Letter of Permissive Change

Subject: Permissive Change for FCC ID: BEJ-WL1BKR23

This is to request Permissive Change for FCC ID: BEJ-WL1BKR23, Originally Granted on 03/09/2023.

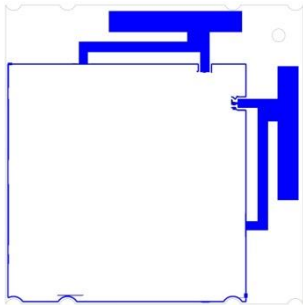
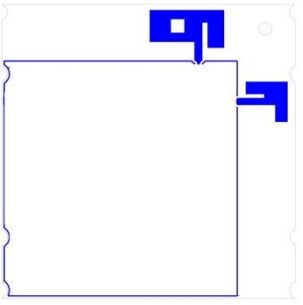
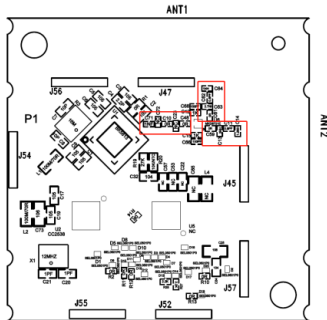
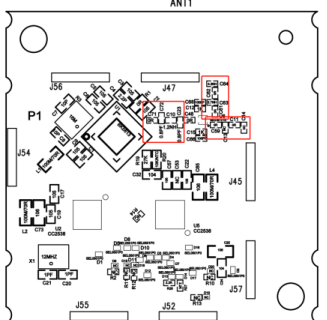
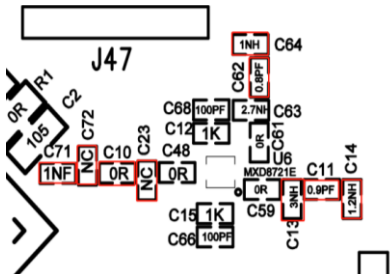
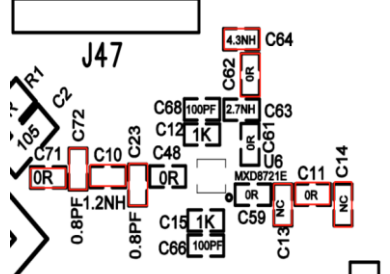
Change: The difference compared with the original is added Frequency by Software and decrease power from the power setting configuration via software change and the RF circuit is identical.

Item	Original	Permissive Change
Model	WL1BKR23	WL1BKR23
Frequency	U-NII Band 3: 5730-5848MHz.	To add Frequency by Software. U-NII Band 1: 5155-5245MHz U-NII Band 3: 5730-5848MHz
Software Version	V1.1	V1.6
Hardware version	V1.3	V1.6
Antenna Shape.		To change Antenna Shape. 
Components	Original	To change Internal Components are mainly for the new Antenna Shape (C71, C72, C10, C23, C13, C11, C14, C62 and C64) Please see as below red mark.
